CALVERT CLIFFS NUCLEAR POWER STATION, UNIT NO. 1

AMENDMENT TO FACILITY OPERATING LICENSE

Amendment No. 67
License Nos. DPR-53

SAFETY EVALUATION BY THE OFFICE OF NUCLEAR REACTOR REGULATION

Figure 3.7-1
Steam Generator Pressure vs. Auxiliary Feedwater Flow

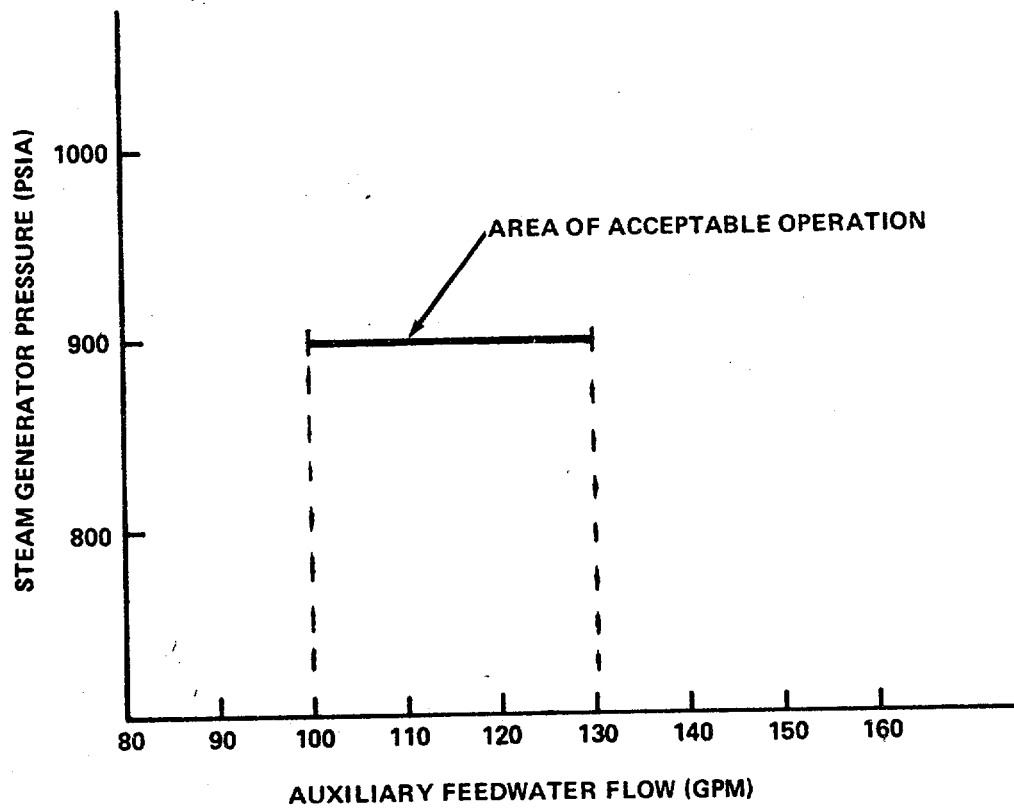
3.7.1.2 At least two steam turbine driven steam generator auxiliary feedwater pumps and associated flow paths shall be OPERABLE and capable of automatically initiating flow, within the area of acceptable operation of Figure 3.7-1, to each steam generator.

3. Verifying, upon automatic initiation of auxiliary feedwater, a flow within the acceptable operating limits of Figure 3.7-1, Steam Generator Pressure Versus Auxiliary Feedwater Flow.
- *d. Upon repositioning of 1/2-CV-4511 and/or 1/2-CV-4512 the valve shall be realigned to provide flow consistent with Figure 3.7-1.

A minimum flow of 88 gpm (plus 12 gpm for instrument error) and a maximum flow of 142 gpm (minus 12 gpm for instrument error) to each steam generator when automatically initiating AFW flow for a steam generator pressure of 900 psia, is required to ensure sufficient time for Operator action to maintain an adequate heat sink for the reactor. Figure 3.7-1 shows the allowable minimum and maximum flows.

Figure 3.7-1
Steam Generator Pressure vs. Auxiliary Feedwater Flow

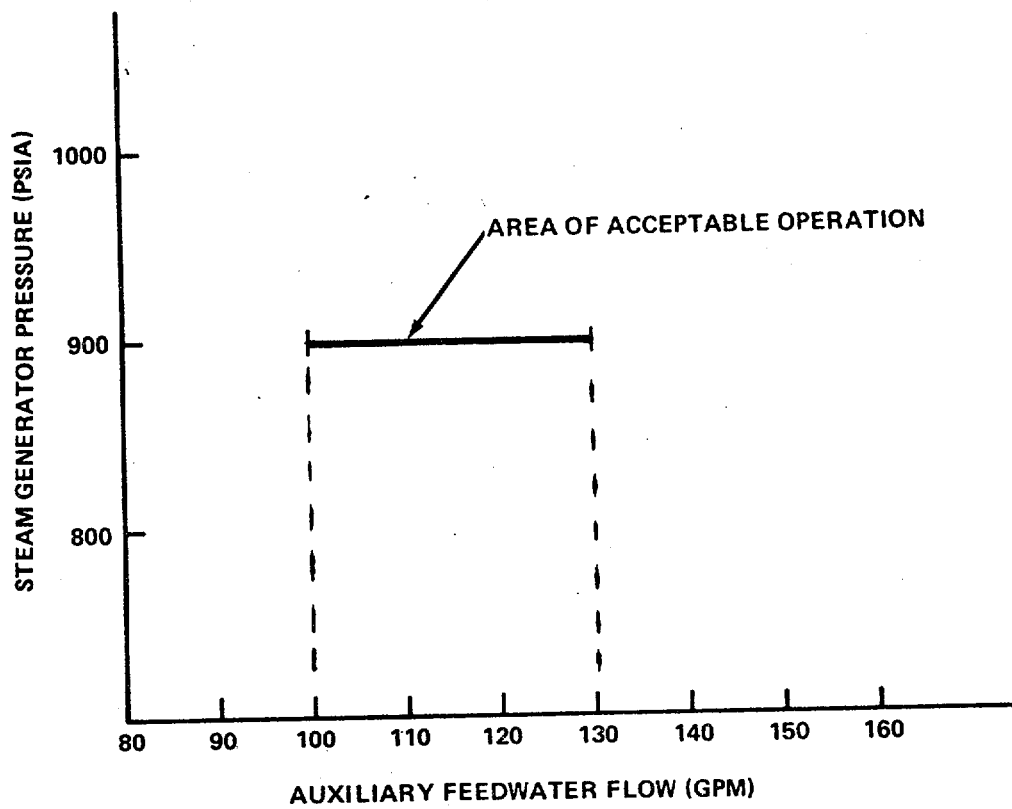
3. Verifying, upon automatic initiation of auxiliary feedwater, a flow within the acceptable operating limits of Figure 3.7-1, Steam Generator Pressure Versus Auxiliary Feedwater Flow.
- *d. Upon repositioning of 1/2-CV-4511 and/or 1/2-CV-4512 the valve shall be realigned to provide flow consistent with Figure 3.7-1.

3.7.1.2 At least two steam turbine driven steam generator auxiliary feedwater pumps and associated flow paths shall be OPERABLE and capable of automatically initiating flow, within the area of acceptable operation of Figure 3.7-1, to each steam generator.

A minimum flow of 88 gpm (plus 12 gpm for instrument error) and a maximum flow of 142 gpm (minus 12 gpm for instrument error) to each steam generator when automatically initiating AFW flow for a steam generator pressure of 900 psia, is required to ensure sufficient time for Operator action to maintain an adequate heat sink for the reactor. Figure 3.7-1 shows the allowable minimum and maximum flows.
